UNITED STATES PATENT AND TRADEMARK OFFICE

APPLICATION NO.	FILING DATE	FIRST NAMED INVENTOR	ATTORNEY DOCKET NO.	CONFIRMATION NO.
10/783,394	02/21/2004	Michael G. Feucht	087801-9308-00	6436

Office Action Summary	Application No. 10/783,394	Applicant(s) FEUCHT ET AL.	
	Examiner Suzanne Dino Barrett	Art Unit 3676

DETAILED ACTION

FIG. 1

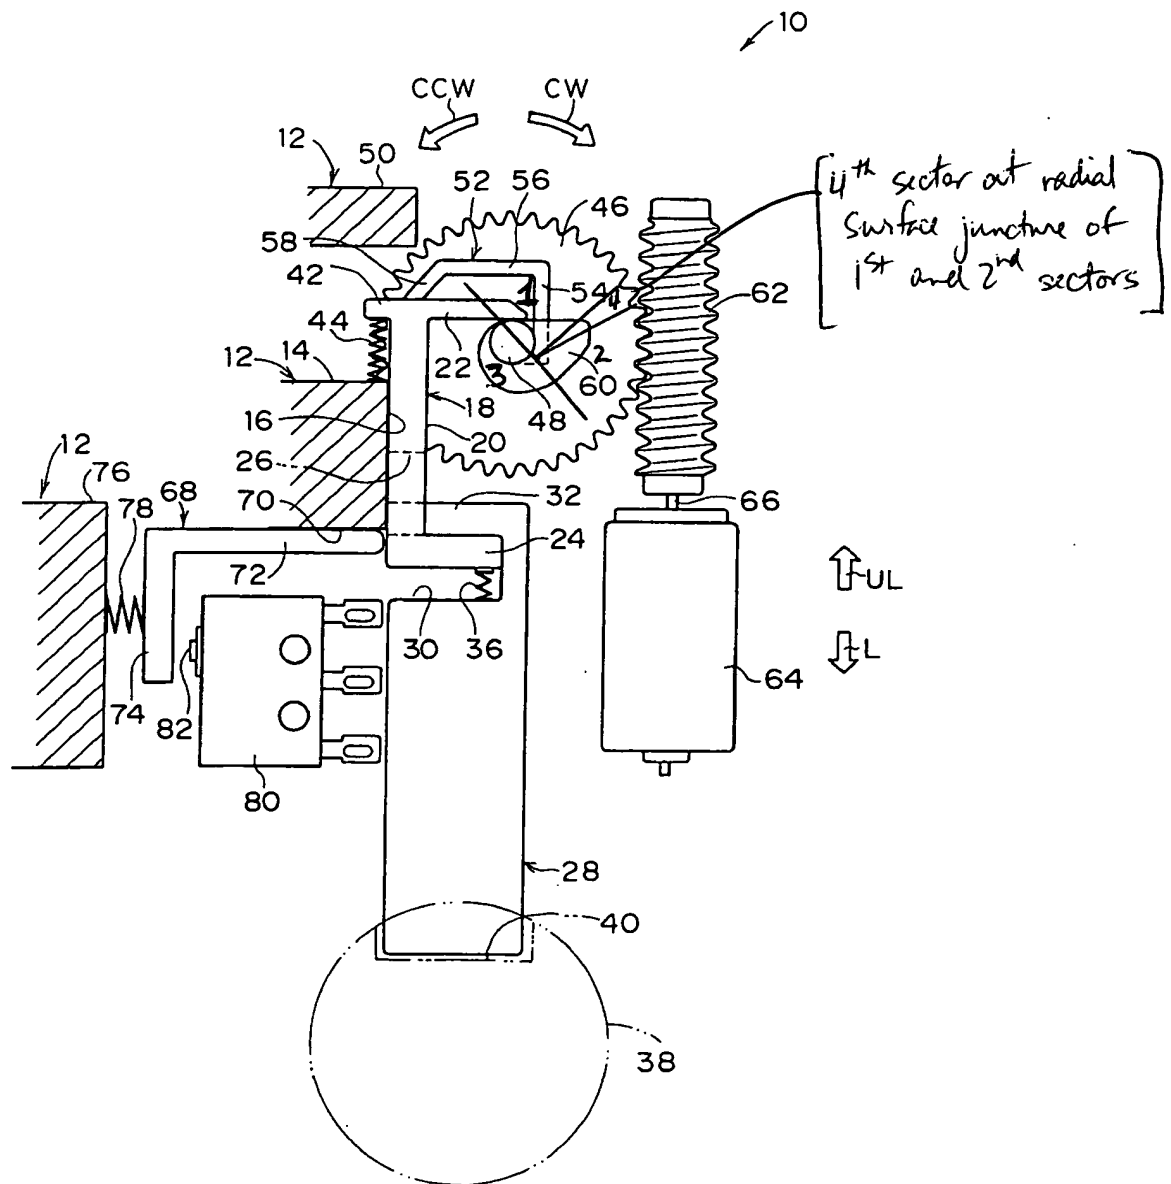
2. Claims 1-3,6-10,15,16,18,19 are rejected under 35 U.S.C. 102(e) as being anticipated by Fukatsu et al 2004/0182121. Fukatsu et al teach a steering column lock comprising a motor actuator 64, gears 62, lock bolt 28, microswitch sensor means 80 and eccentric cam 60. Fukatsu is deemed to teach a cam 60 having four sectors as

claimed, and further having the third sector defined by a greater circumferential portion of the cam than the fourth sector as set forth in claim 1. Note cam 60 as depicted in Figures 6A-6C especially, showing the various sectors in operation. For Applicant's convenience, the Fukatsu cam 60 is divided into 4 sectors as shown below for the purposes of this rejection. Note that the juncture between the long flat portion (1st sector) and the short flat portion (2nd sector) is a radial surface (see instant specification, page 15, lines 17-27 and line 19 especially), which is considered to be the 4th sector.

7. Applicant's arguments filed 1/23/06 have been fully considered but they are not persuasive. As set forth in the rejection above, it is maintained that Fukatsu teaches a radial portion between the ends of the first and third sectors which, contrary to applicant's arguments, is not a true right angle, but rather a curved juncture between the first and second sectors, which is considered a sector to satisfy the claim language set forth in claim 1. Accordingly, claims 1-3,6-13,15-19 stand rejected.
